**Rezoning from "Residential (Group C) 2" and "Open Space" zones to
"Residential (Group C) 4" zone for a Proposed Residential Development
at Lot Nos. 519 RP (part) and 520 RP in D.D. 110 and adjoining Government land,
Shek Kong, Yuen Long, N.T.**

(S12A Amendment of Plan Application No. Y/YL-KTN/6)

- Further Information No. 2 -

Comments Forwarded from Fanling, Sheung Shui and Yuen Long East District Planning Office (FSS&YLE DPO)

Proposed Drainage System

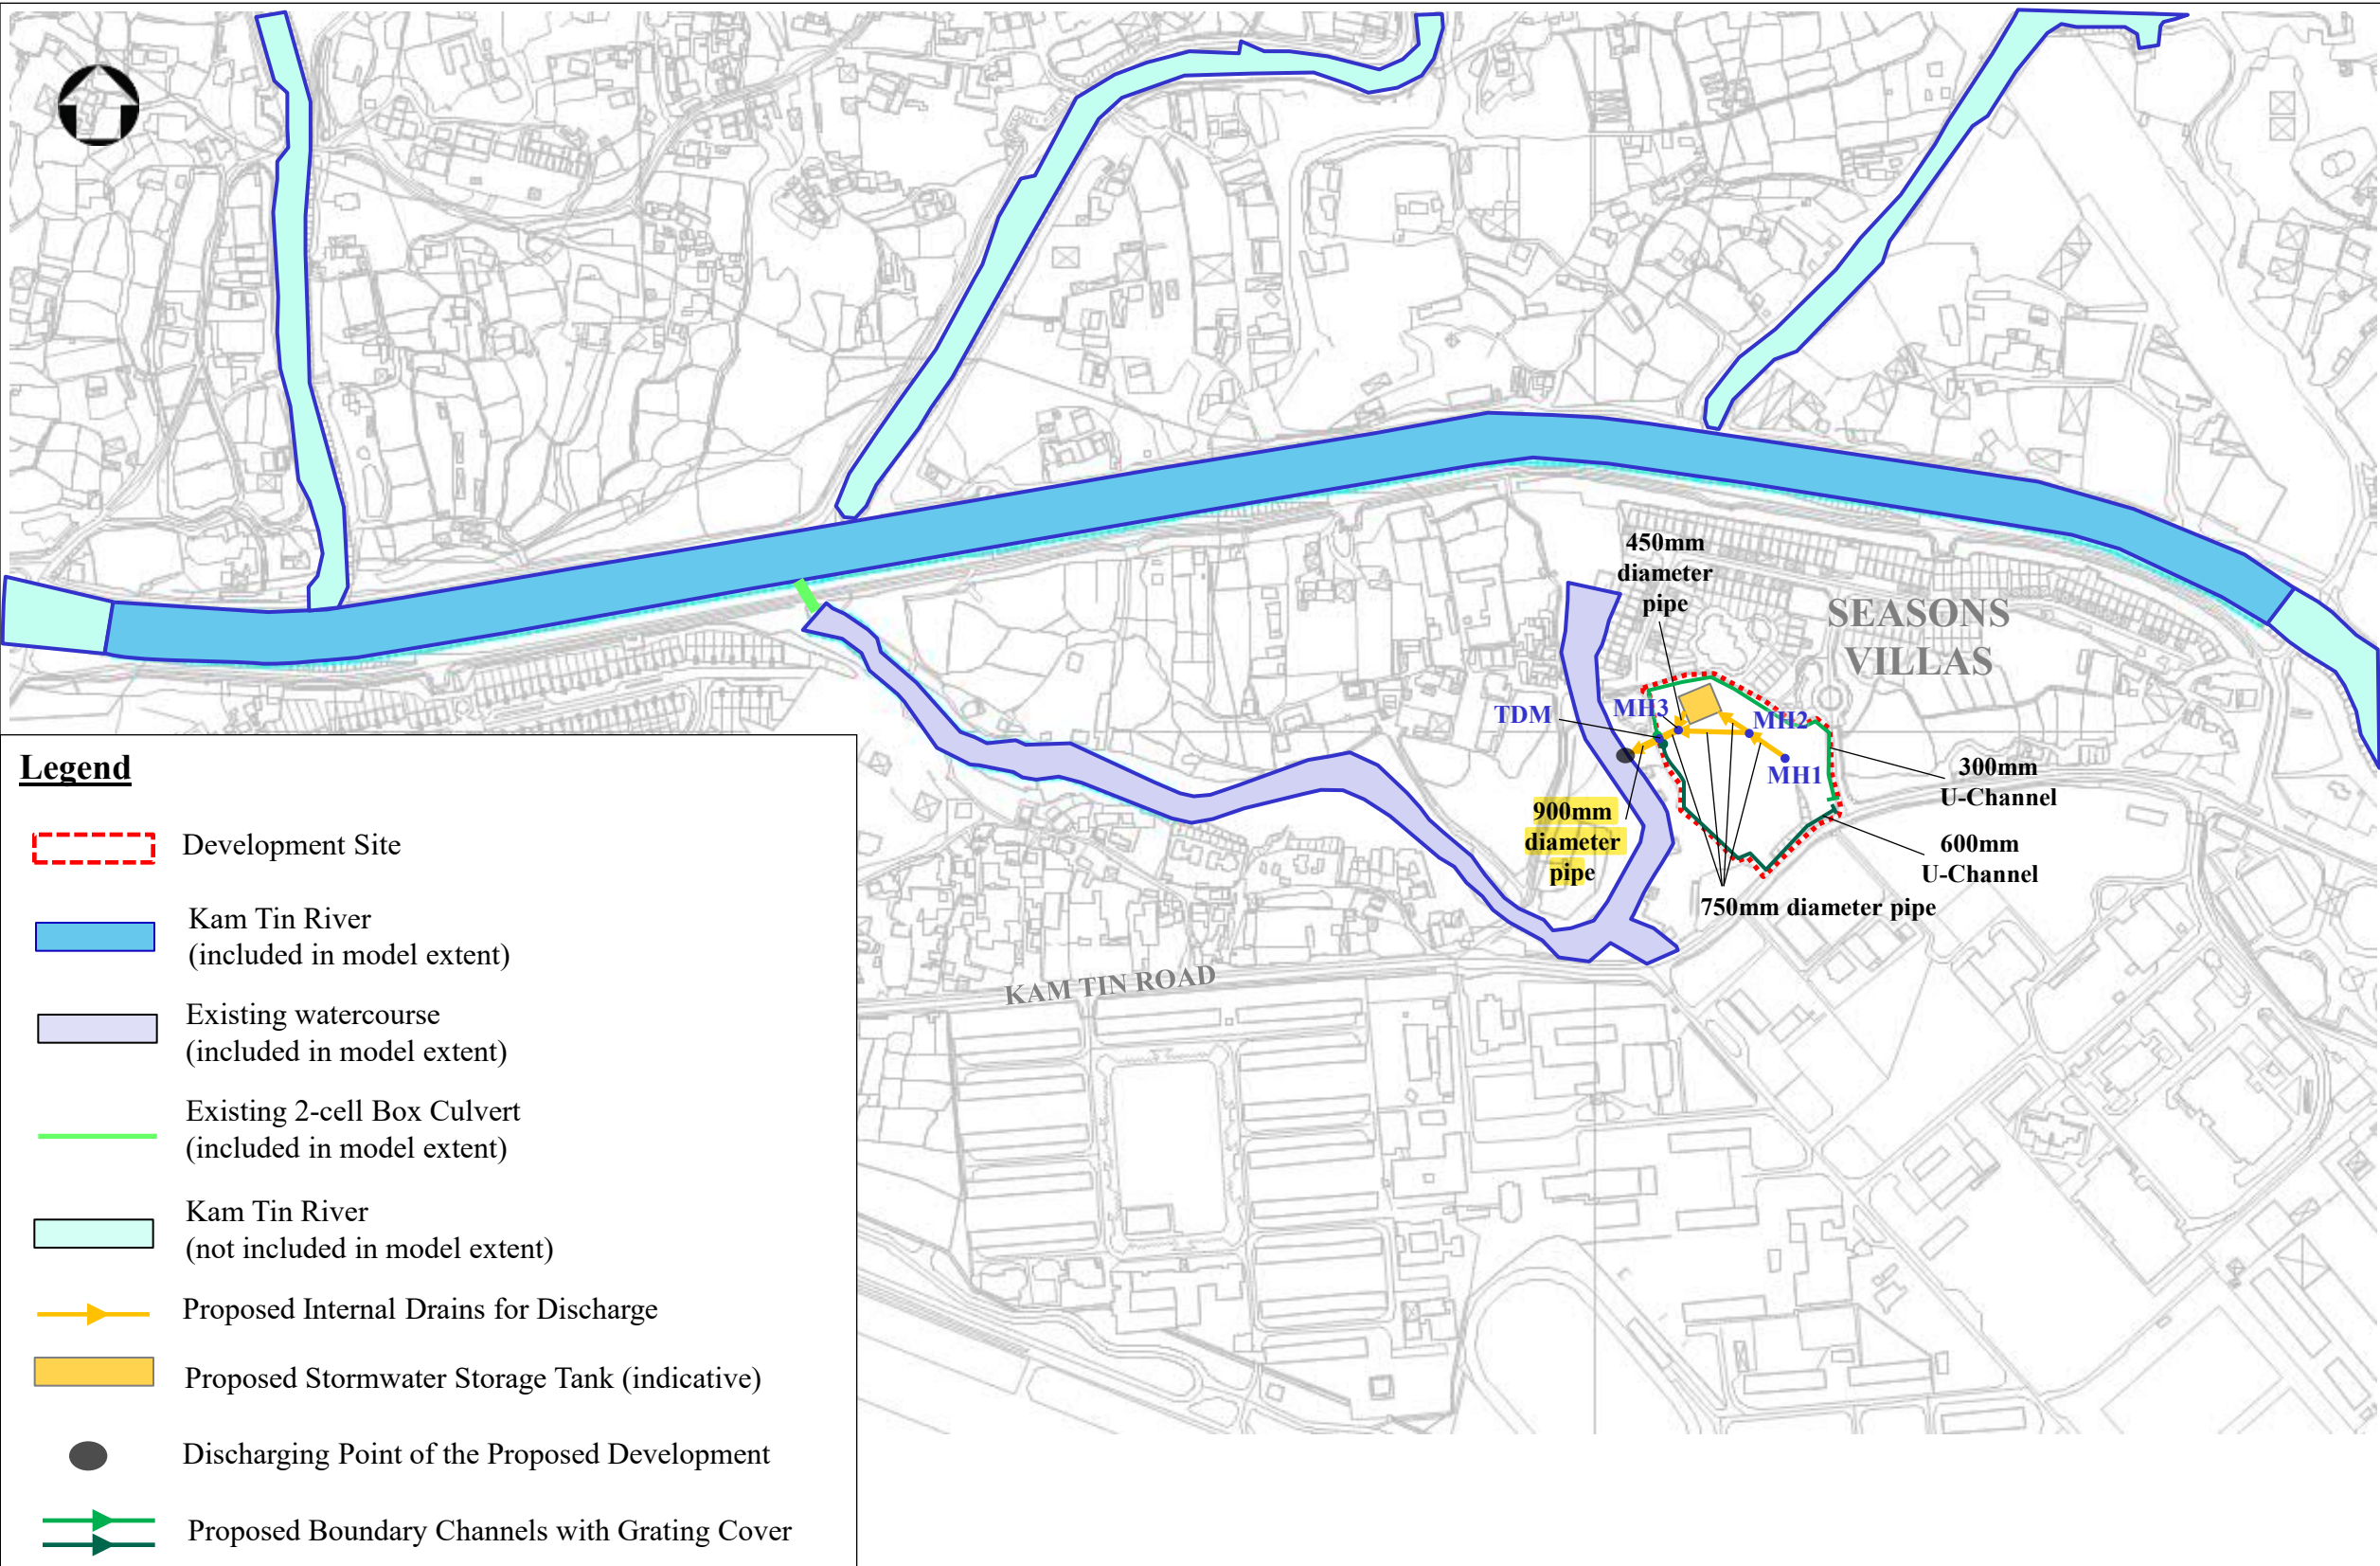
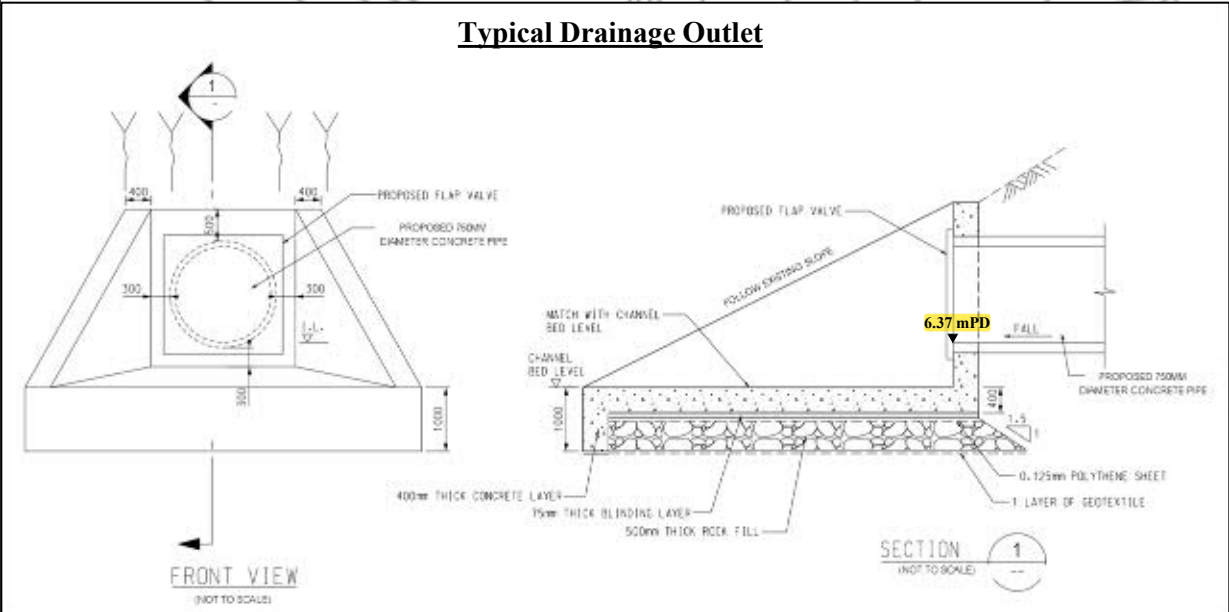
3 The applicant should clarify gradient and invert levels of all proposed drainage facilities. Invert levels of the drainage facilities at the upstream shall be higher than that at the downstream.	Invert levels and gradients of all the proposed pipes and proposed channels are shown in Appendix B2. All the drainage facilities have higher invert levels at the upstream as compared to that at the downstream.
4 A sand trap/desilting type catchpit should be provided prior to connection to the proposed stormwater terminal manhole or to the downstream public stormwater drainage system. The sand trap/desilting type catchpit should be regularly desilted by the applicant to prevent sand, silt, cementitious materials or other objects from being washed down into the existing stormwater drainage system.	Sand trap/desilting type catchpits has been provided prior to the connection to the proposed stormwater terminal manhole as shown in enlarged plan in Appendix B2. Regular desilting will be carried out by the owner/ management office of the Proposed Development.

11 Catchpit should be provided at where a proposed surface channel changes direction / gradient.	Catchpits will be provided where a proposed surface channel changes direction / gradient. The proposed catchpits, as well as catchpits with sand trap for the proposed drainage system are also included in the enlarged plan in Appendix B2 .

From	To	Size (mm)	US I.L. (mPD)	DS I.L. (mPD)	Gradient 1 in
MH1	MH2	750	8.870	8.800	212
MH2	SST	750	8.400	8.300	194
SST	MH3	450	7.400	7.320	193
MH2	MH3	750	8.800	8.660	195
MH3	TDM	750	6.720	6.675	193
TDM	watercourse	900	6.525*	6.370	182
C1	TDM	600	6.750	6.730	100
C2	TDM	300	7.080	7.070	200

- Note:
- US I.L. = Upstream Invert Level
 - DS I.L. = Downstream Invert Level
 - * means D.T.I.L. of terminal manhole
 - TDM = Terminal manhole. The type of terminal manhole will be made reference to DSD latest standard drawings in detailed design stage
 - C1 & C2 details will be made reference to DSD Standard Drawing No. DS1025.
